**CERTIFICATE OF APPROPRIATENESS**

**Property:** 8011 Glen Valley Drive, lot 4, block 6, Glenbrook Valley Section 2 Subdivision. The property includes a historic 2,395 square foot brick single family residence situated on a 14,699 square foot (150, by 95') interior lot.

**Proposal:** Alteration – *Resubmittal* Replace 17 of the house’s original windows on the front and side elevations. This work has already been performed and was reported by a neighbor.

**WINDOWS 1, 2, AND 3 - FRONT FACING GLEN VALLEY DRIVE**  
**PREVIOUSLY EXISTING**

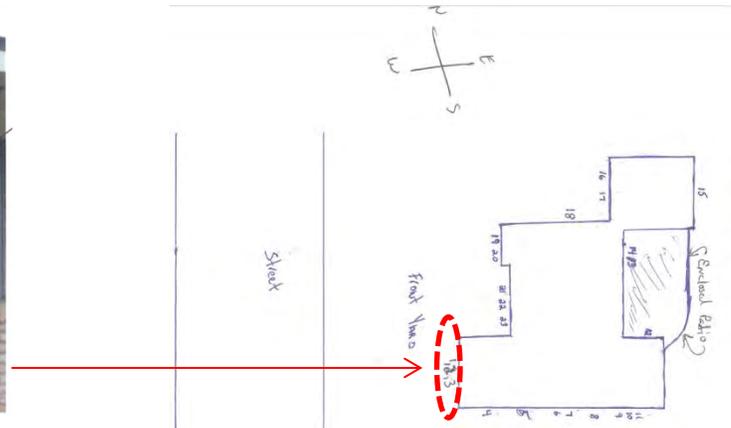
**Front Elevation (West):** Viewing the house from the street, Windows 1, 2, and 3 were a contiguous row of metal 1 over 1 windows on the right side of the front elevation. These were replaced with matching vinyl windows.

**WINDOWS 21, 22, AND 23 – FRONT FACING GLEN VALLEY DRIVE  
PREVIOUSLY EXISTING**

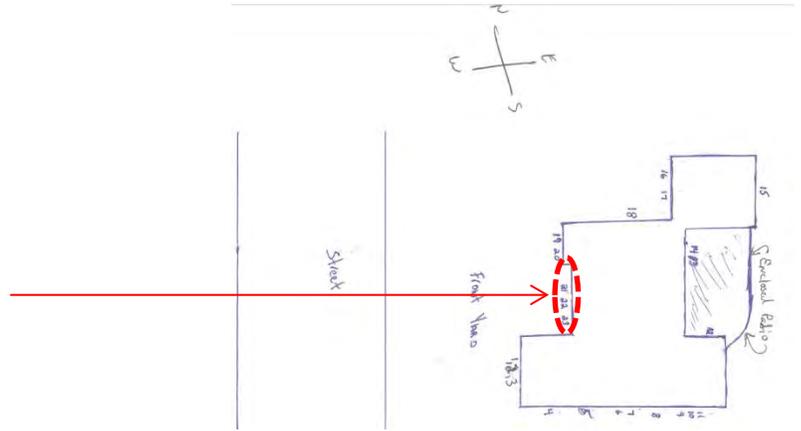
Windows 21, 22, and 23 were the metal framed picture window flanked by a pair of 4 lite horizontal lite windows. These were replaced with a vinyl picture window flanked by a pair of 1 over 1 vinyl windows installed within the existing window openings.

**WINDOWS 19 AND 20 – FRONT FACING GLEN VALLEY DRIVE  
PREVIOUSLY EXISTING**

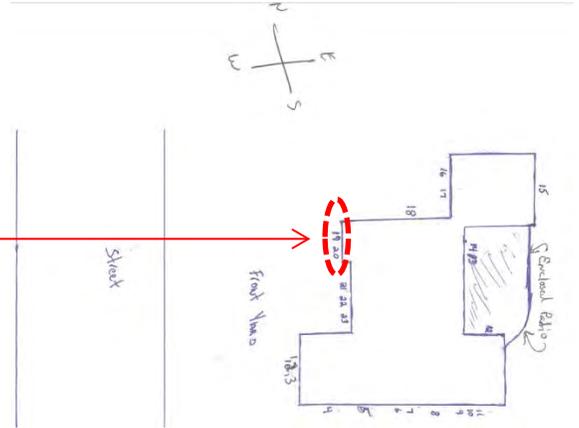
Windows 19 and 20 were a pair of 4 lite horizontal lite metal windows on the left side of the front elevation. These were replaced with vinyl 1 over 1 windows installed within the existing window openings.

**WINDOW 18 – FACING NORTH SIDE PROPERTY LINE  
PREVIOUSLY EXISTING**

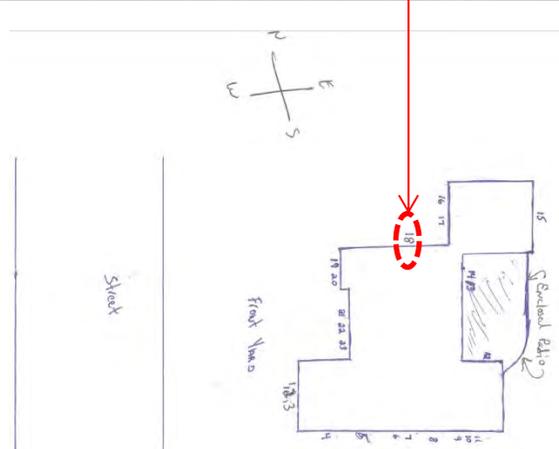
**Side Elevation (North):** Window 18 was a 1 over 1 metal framed window. It was replaced with a vinyl 1 over 1 window.

WINDOW 4 – FACING SOUTH SIDE PROPERTY LINE

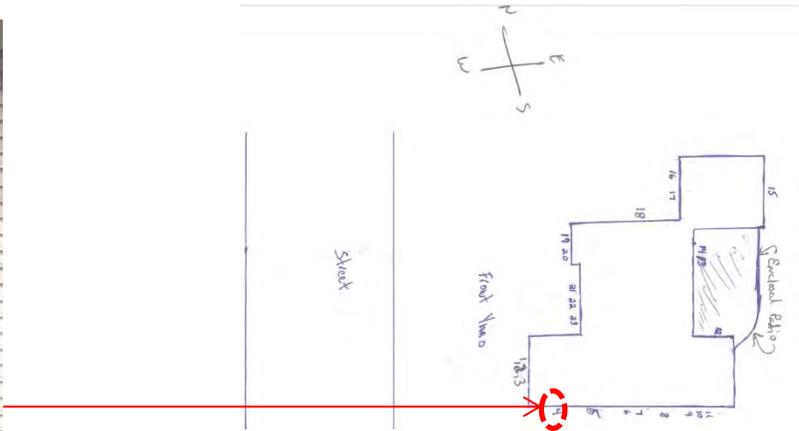
**Side Elevation (South):** Viewing from front to back: Window 4 was a 4 lite horizontal lite window. It was replaced with a vinyl 1 over 1 window installed within the existing opening.

WINDOW 5 AND 8 – FACING SOUTH SIDE PROPERTY LINE

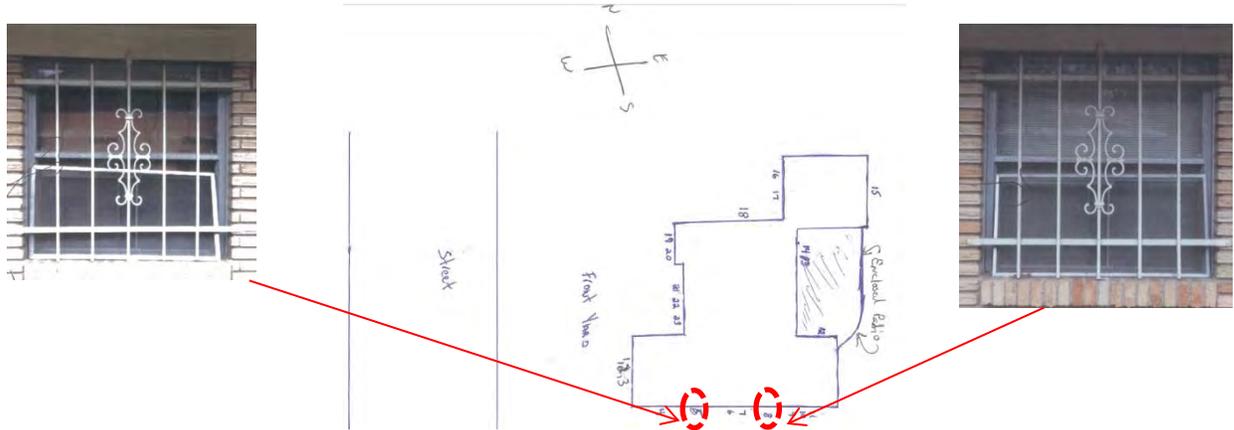
Windows 5 and 8 were 1 over 1 metal windows. They were replaced with matching vinyl windows.

**WINDOWS 6 AND 7 – FACING SOUTH SIDE PROPERTY LINE  
PREVIOUSLY EXISTING**

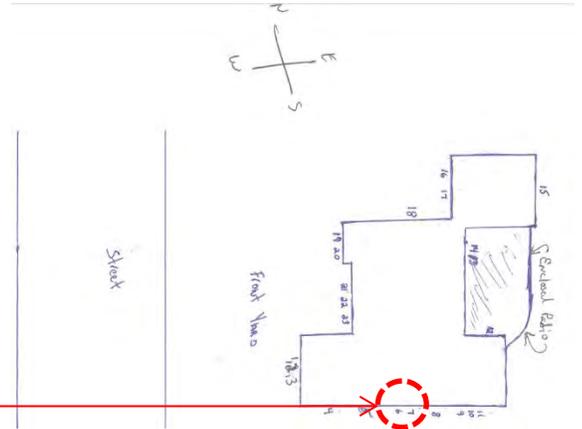
Windows 6 and 7 were 4 lite horizontal lite metal windows. They were replaced with vinyl 1 over 1 windows installed within the existing openings.

**WINDOWS 9, 10, AND 11 – FACING SOUTH SIDE PROPERTY LINE  
PREVIOUSLY EXISTING**

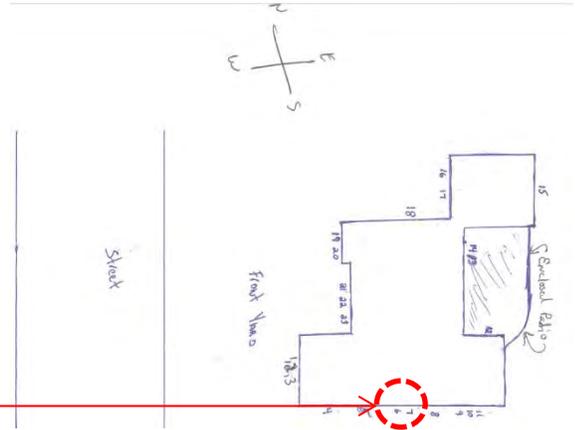
Windows 9, 10, and 11 were a contiguous row of metal 1 over 1 windows. These were replaced with matching vinyl windows.
